Attorney Docket Q67311

For: IMPROVED INTERFACE SYSTEM FOR SYNCHRONOUS HIERARCHY
TELECOMMUNICATIONS NETWORKS

PRELIMINARY AMENDMENT

FIG. 3 Fig. 4

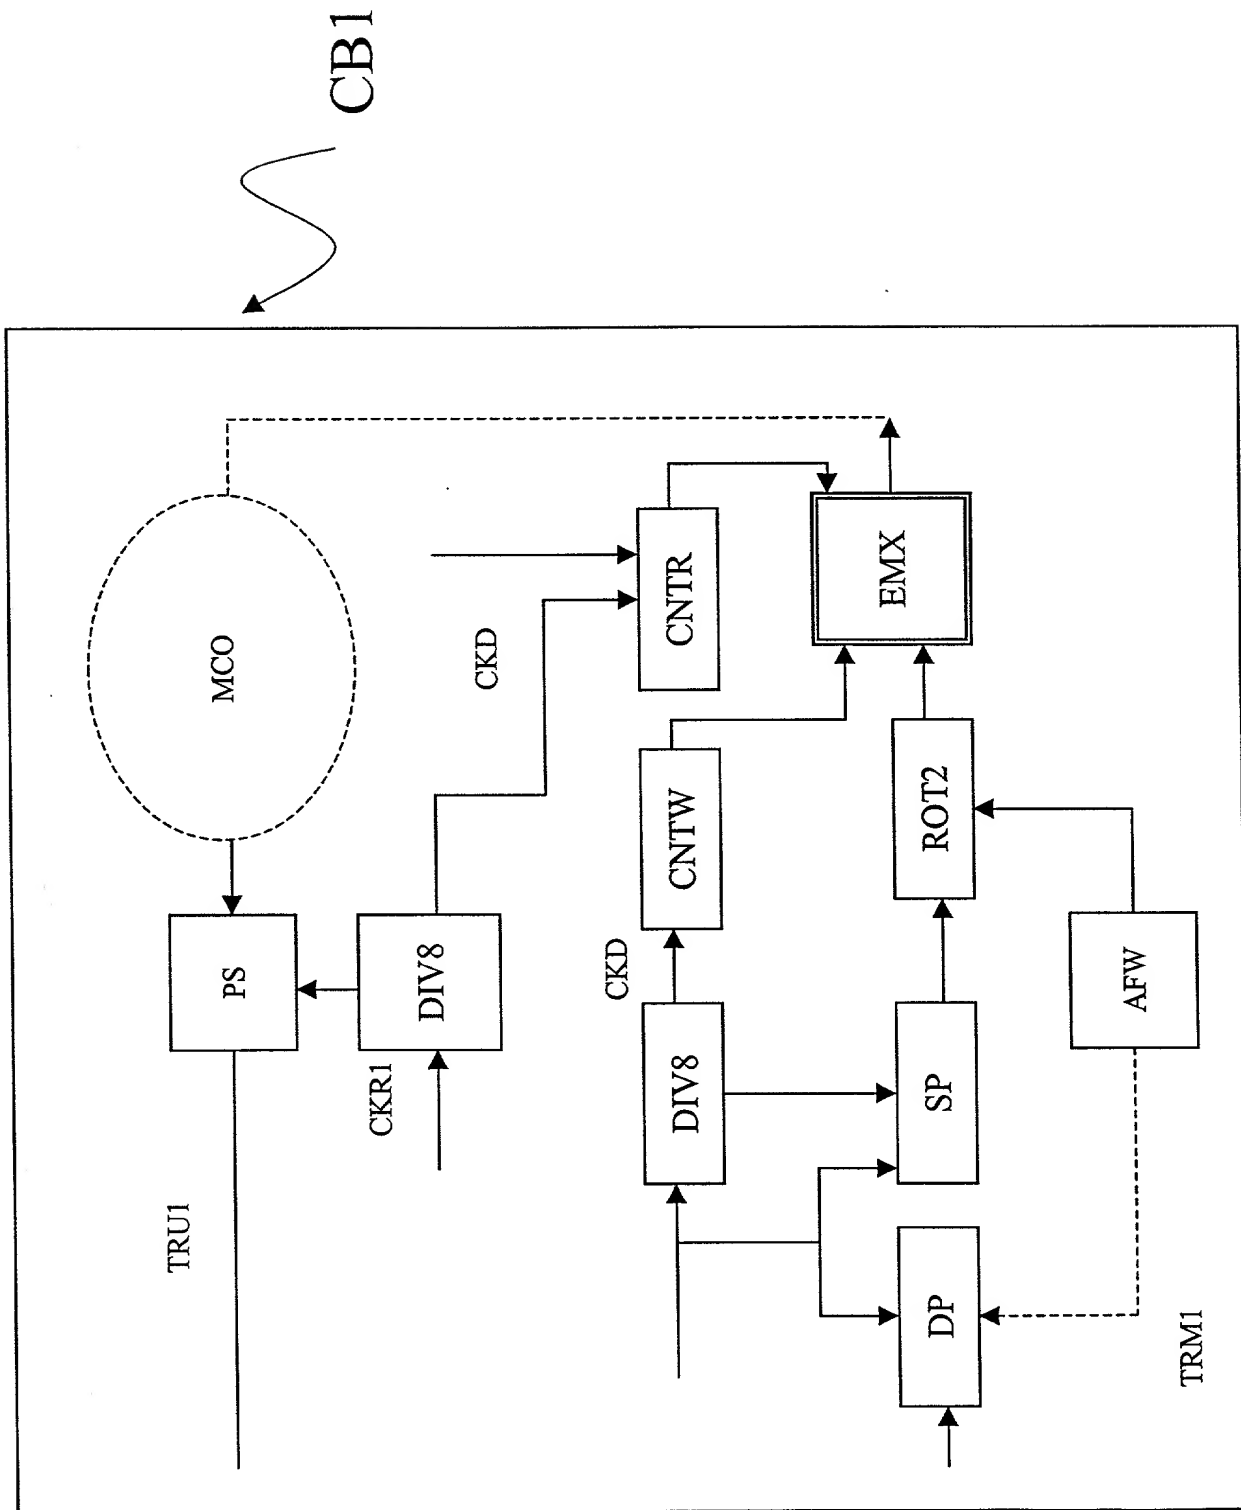
Attached please find *Proposed Corrections to Formal Drawings* relabeling Figure 3 to Figure 4 and Table 3 to Figure 3.

Attached please find *Proposed Corrections to Formal Drawings* relabeling Figure 3 to Figure 4 and Table 3 to Figure 3.

~~Table 3~~
